## Display

Subject: **CROSS TALK**

Model: **PVM-1351Q/1354Q/1954Q**

Serial No: **UNITS WITH BKM-101C INSTALLED**

Figure 1

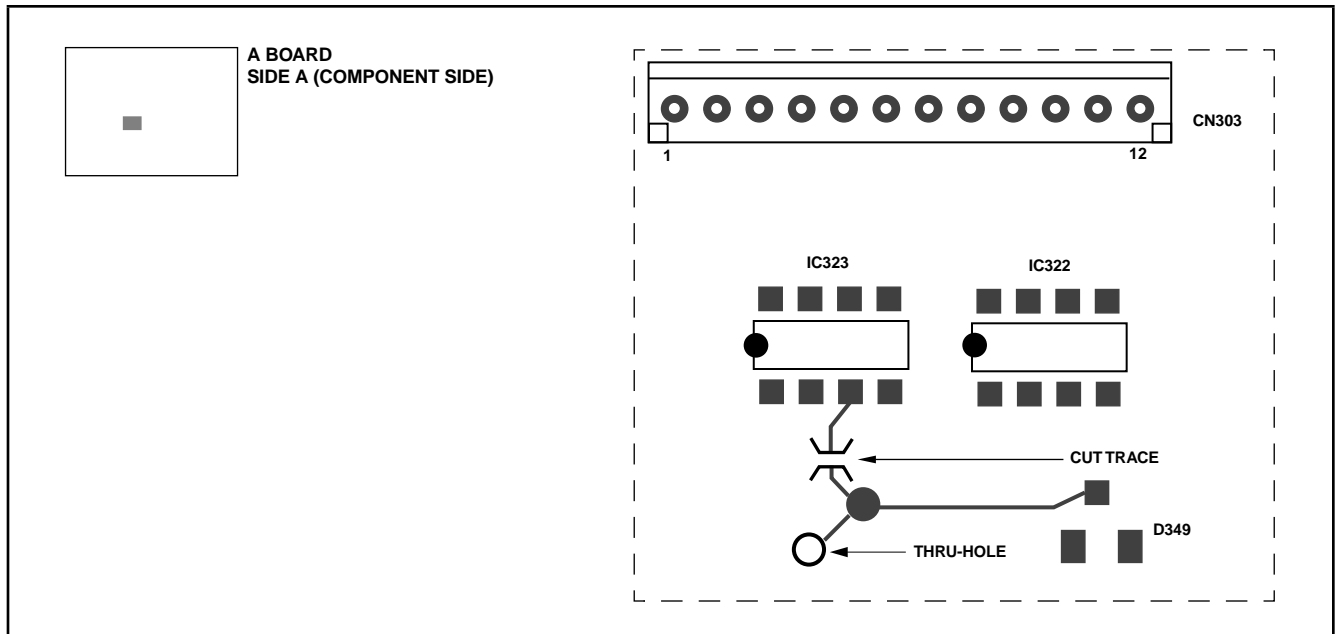
1. Cut trace between IC323-3 and D349 as shown in Figure 1.

Figure 2

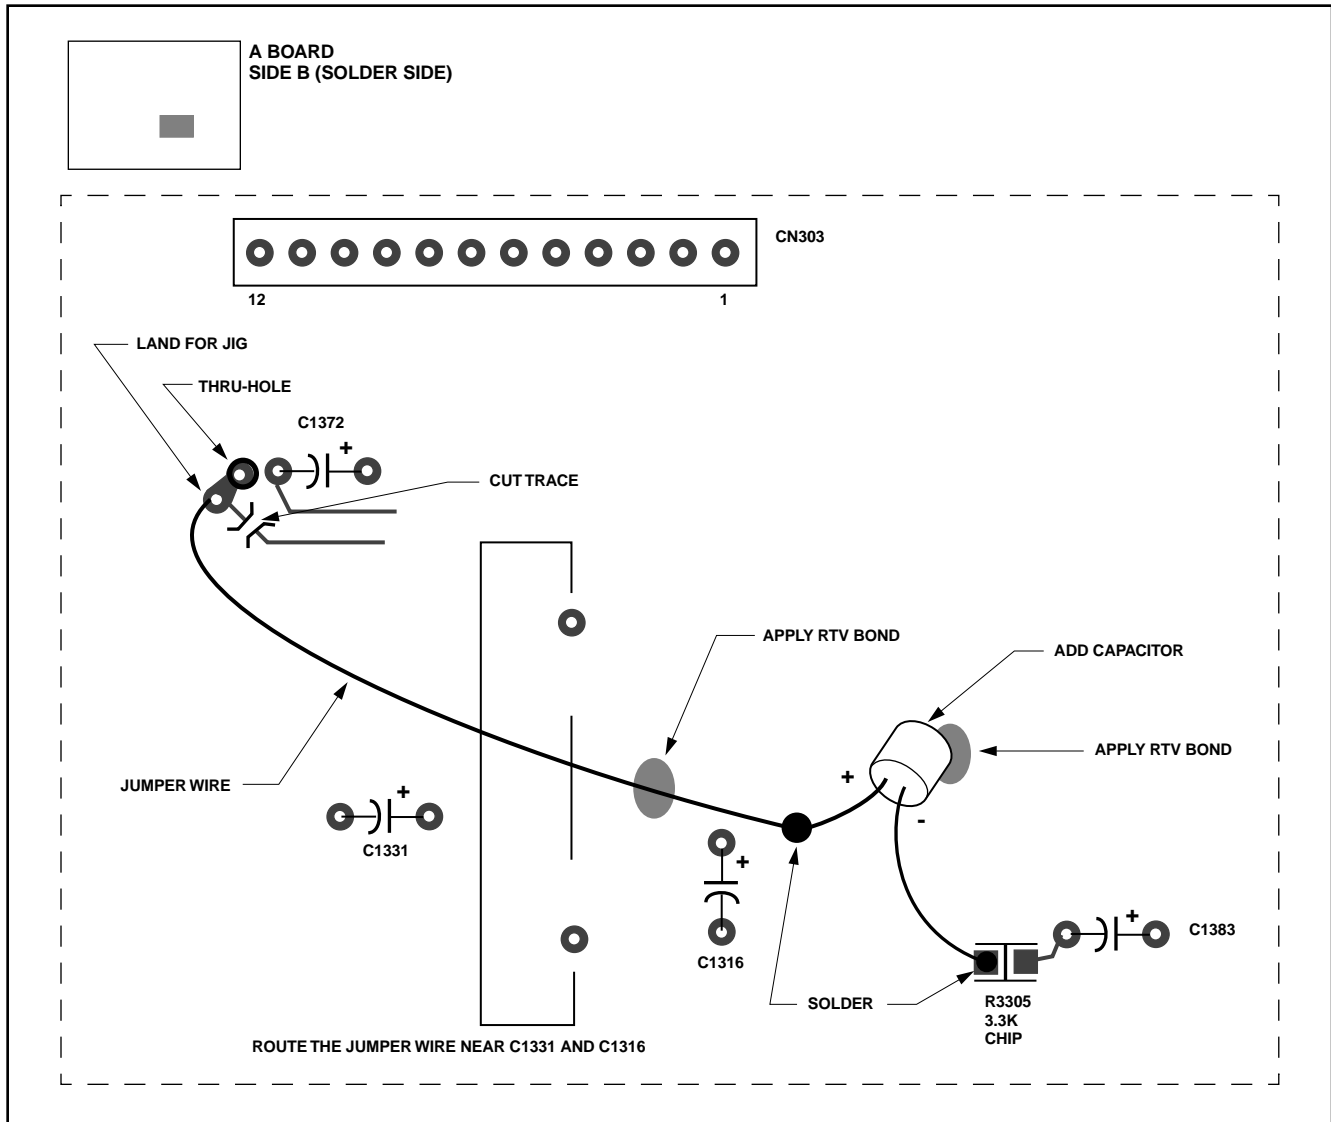
1. Cut trace (zone E-6) as shown in Figure 2.
2. Solder 70mm jumper wire (UL1007, AWG26) to the land for jig.
3. Route the jumper near C1331 (zone F-6) and C1316 (Zone F-7) as shown in Figure 2.
4. Solder end of jumper to positive terminal of electrolytic capacitor (100 $\mu$ F/16V) (zone F-7).
5. Solder negative terminal of capacitor to chip resistor R3305 (zone F-7).
6. Apply RTV bond to jumper wire and capacitor. Attach to the board.
